ADDENDUM #4

Reference: Roofing Improvements – Lightning Peak
Division of Juvenile Justice Services, Provo, Utah
DFCM Project No. 07152430

The following are items for your third addendum on the Lightning Peak Re-roof. DFCM Job # 07152430

AD101

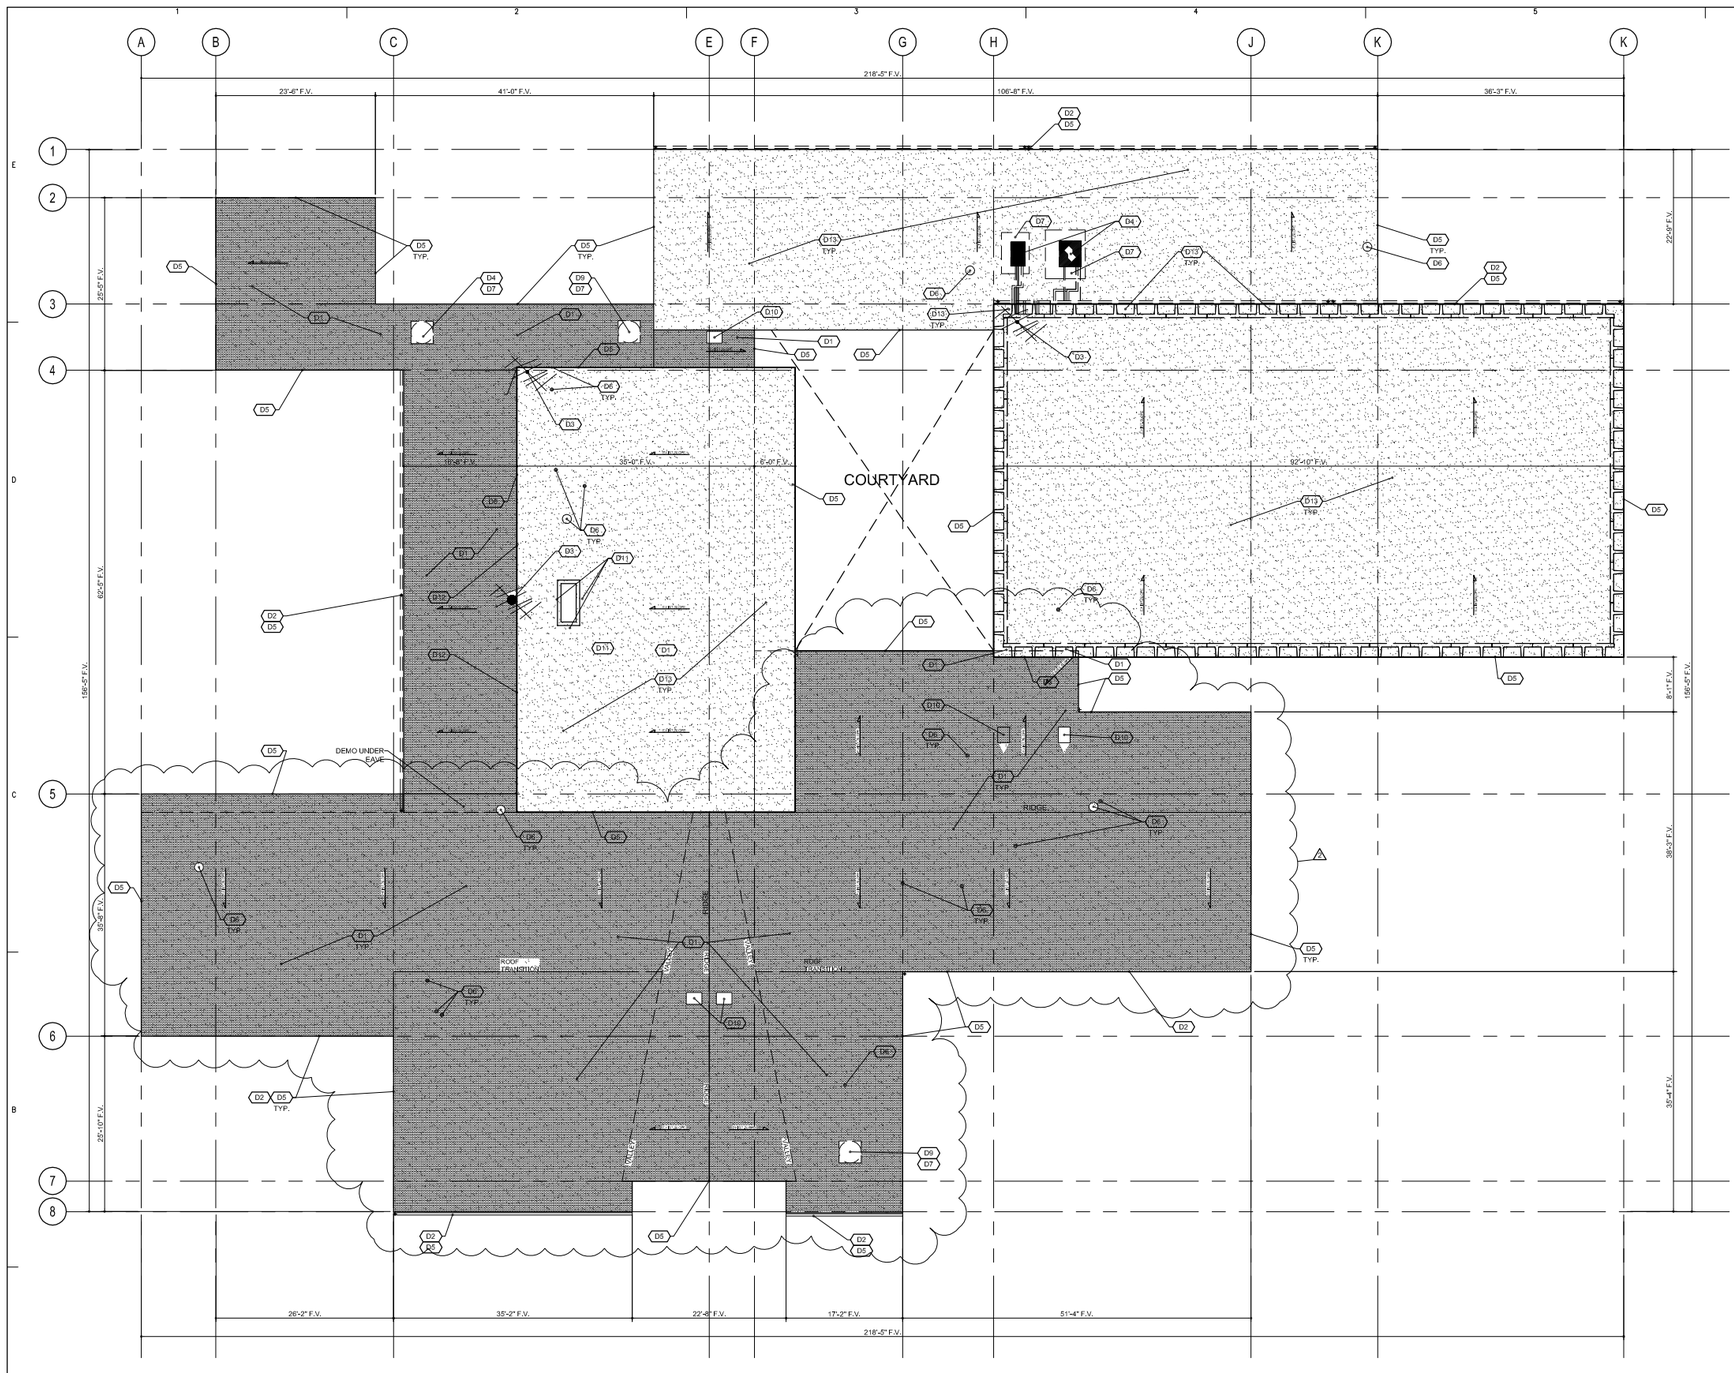
- Sheet AD101 Revised Demolition Keynote D13 to read "Machine scarify and remove existing sprayed applied polyurethane foam roof system as required to receive new roof system. Remove existing polyurethane sprayed on foam roof system from all parapet and double "T" concrete walls. Typical. See attached revised drawing AD101.
- Sheet AE101 Add Keynote 7G to read "New fully adhered single ply membrane over ½" scheduled sheathing over (2) two layers of 1.5 inch Polyisocyanurate insulation board with staggered joints over existing concrete roof deck." See attached revised drawing AE101.
- Sheet AE101 Detail reference change at perimeter. See attached revised drawing AE101.

- D12 REMOVE EXISTING ROOF SYSTEM OFF OF EXISTING WALLS, LOUVERS ETC.
- D13 MACHINE SCARIFY AND REMOVE EXISTING SPRAYED APPLIED POLYURETHANE SPRAYED ON FOAM ROOF SYSTEM DOWN AS REQUIRED TO RECEIVE NEW ROOF SYSTEM. REMOVE FROM ALL PARAPET WALLS AND DOUBLE T CONCRETE WALLS TYP.

DET NUMBER: RF-01

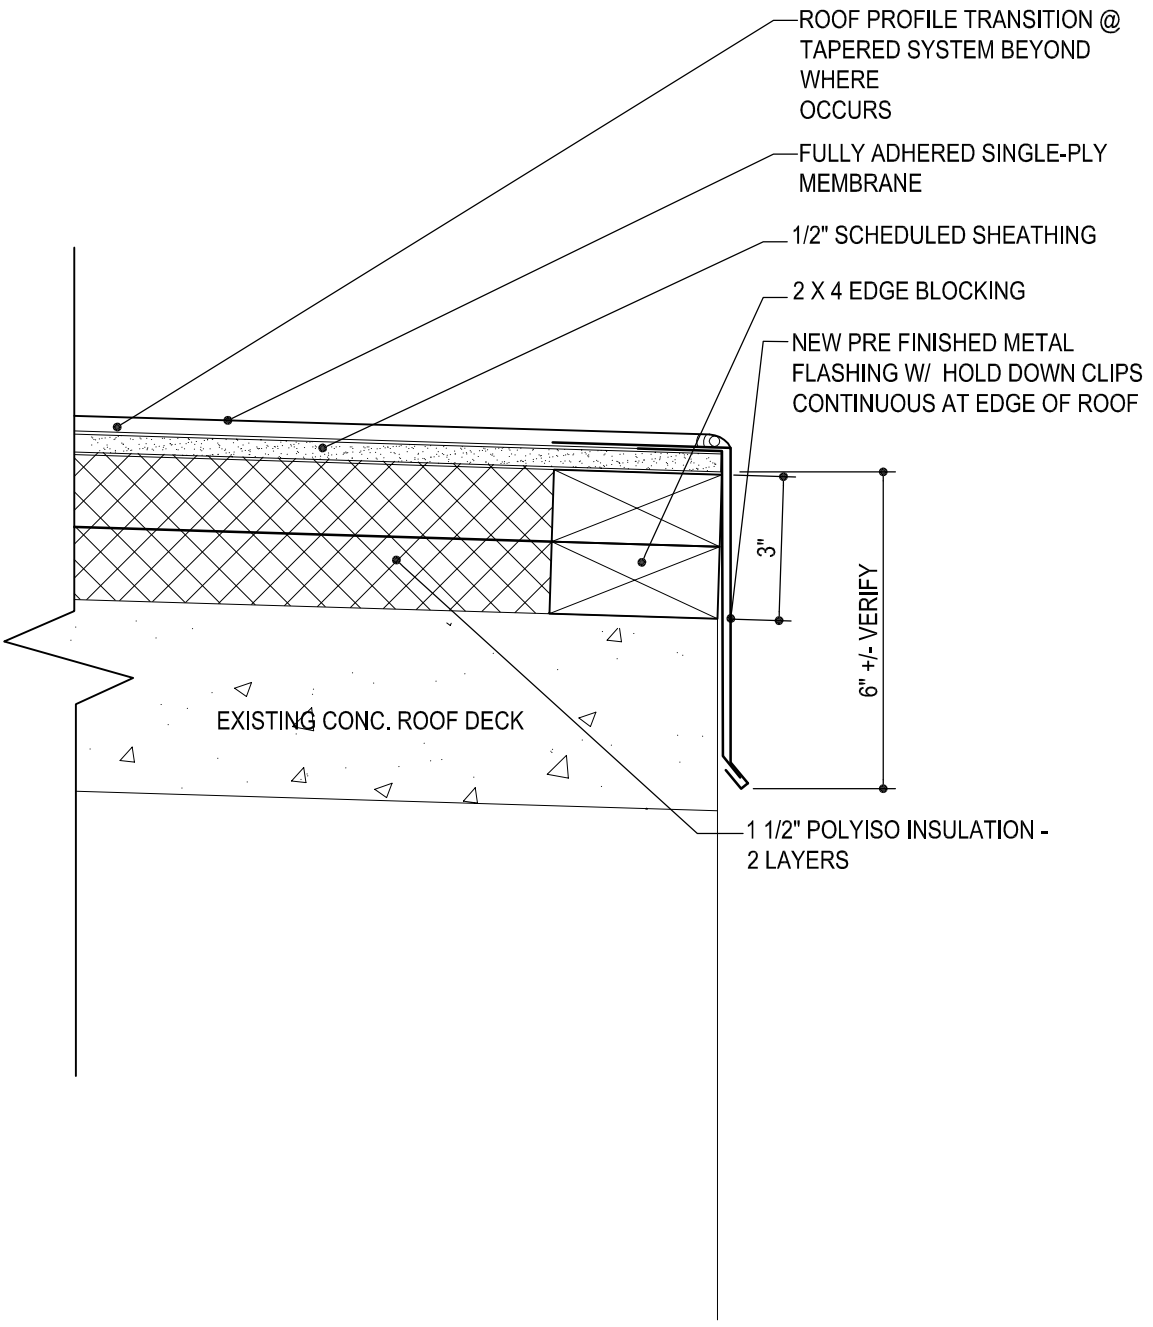
- Revise detail RF-01. See attached revised detail RF-01 Roof Edge Detail
- Revise detail RF-05. See attached revised detail RF-05 New Gutter @ Roof Edge Detail
- Revise detail RF-07. See attached revised detail RF-07 Roof Edge & Gutter Detail
- Revise detail RF-09. See attached revised detail RF-09 Roof Edge Detail
- Add new detail RF-11. Roof edge detail and gutter.

RF-11

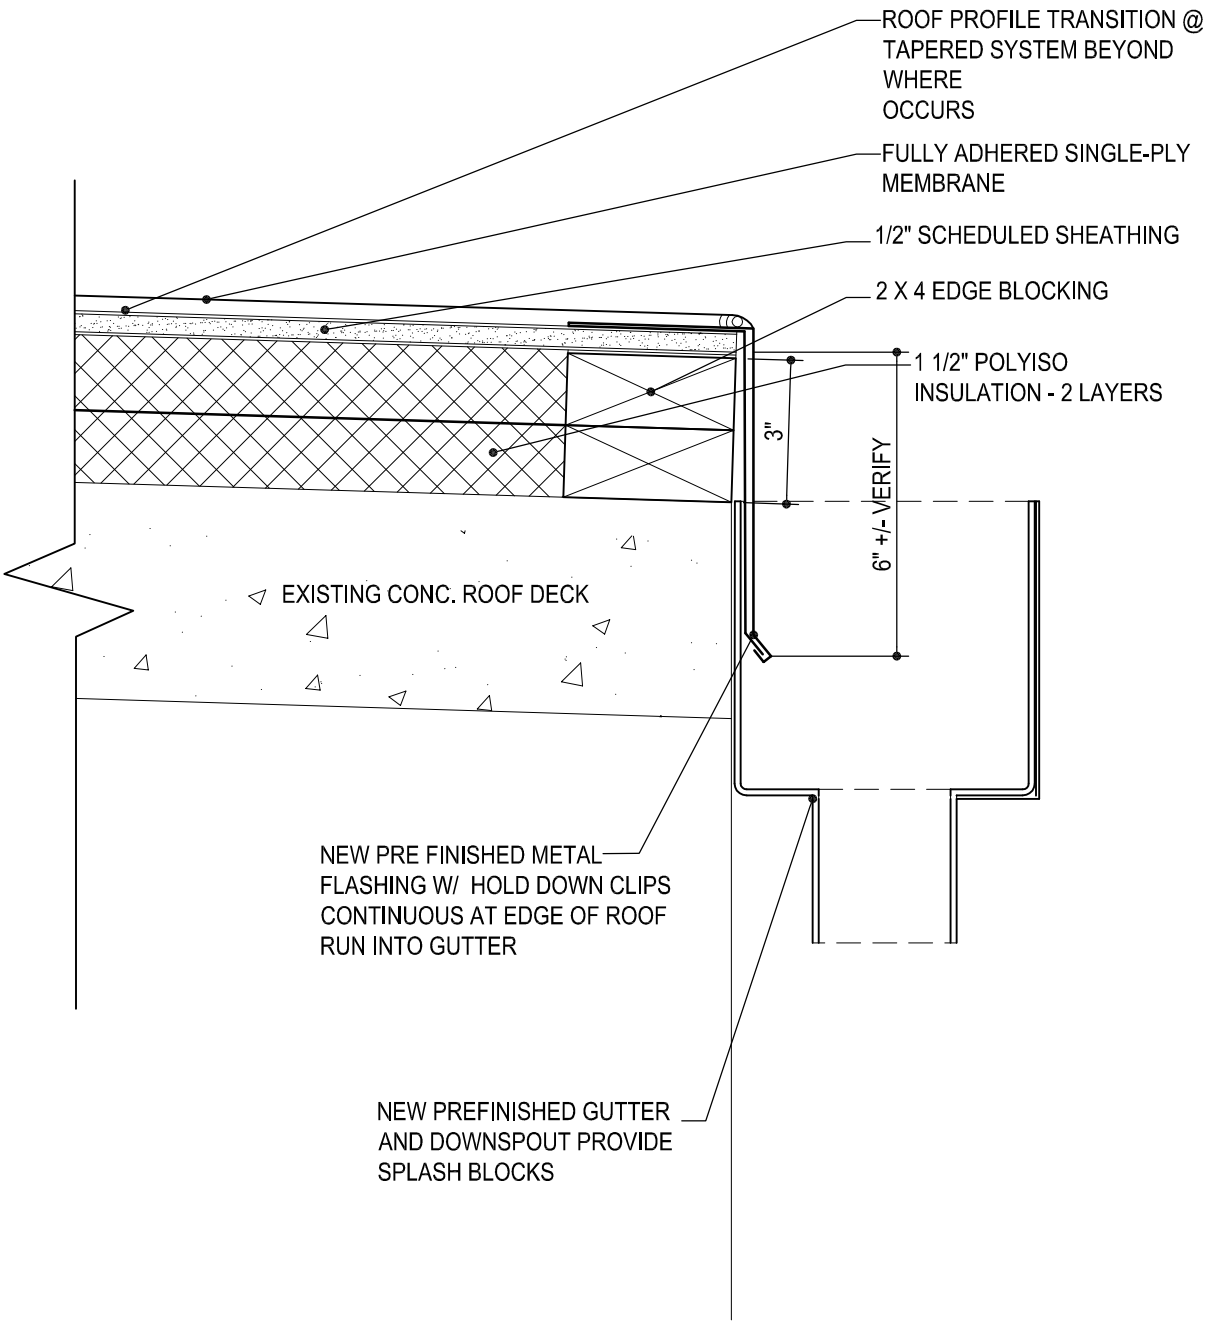
* Note contractor to add new wood nailers at perimeter of all roofs, typical.
